IMPORTANT SAFETY RECALL NOTICE

Dear TPV Homeland Security Vehicle Owner:

Oshkosh Corporation has decided that a defect which relates to motor vehicle safety exists in certain TPV Homeland Security Vehicles

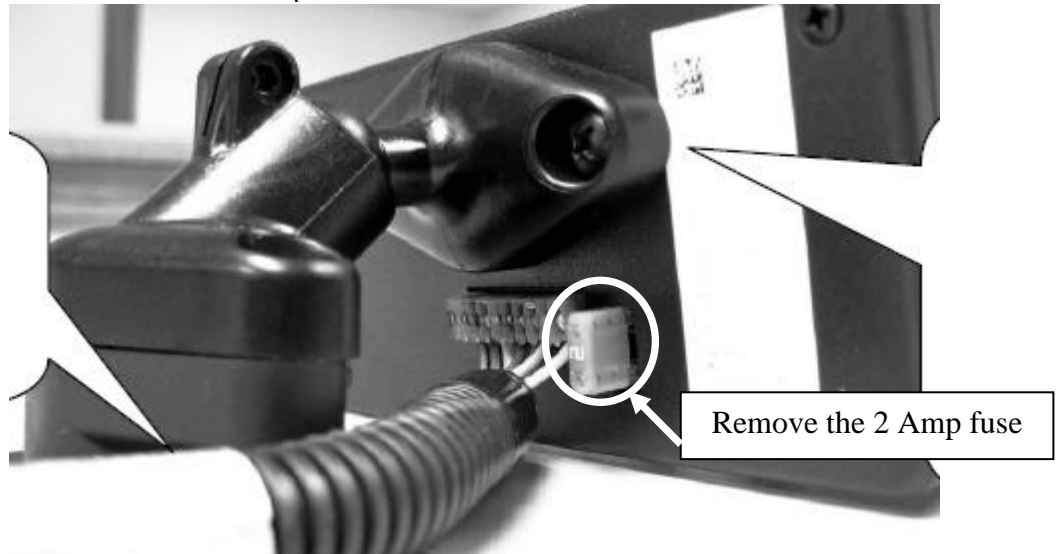
While waiting for the remedy you can eliminate the risk of fuel tank pressurization by completing the following procedure:

1. Locate the TRAX II Module that is mounted to the top of the dash on the on the Driver's side

2. Remove the 2.0 Amp fuse located at the rear of the TRAX II module

3. Store the fuse in a safe place until the remedy is completed.

Removal of the 2.0 Amp fuse disables the Transfer Flow system and prevents the transfer of fuel from the auxiliary tank to the main tank. The gas gauge will now indicate fuel remaining in the main tank only.
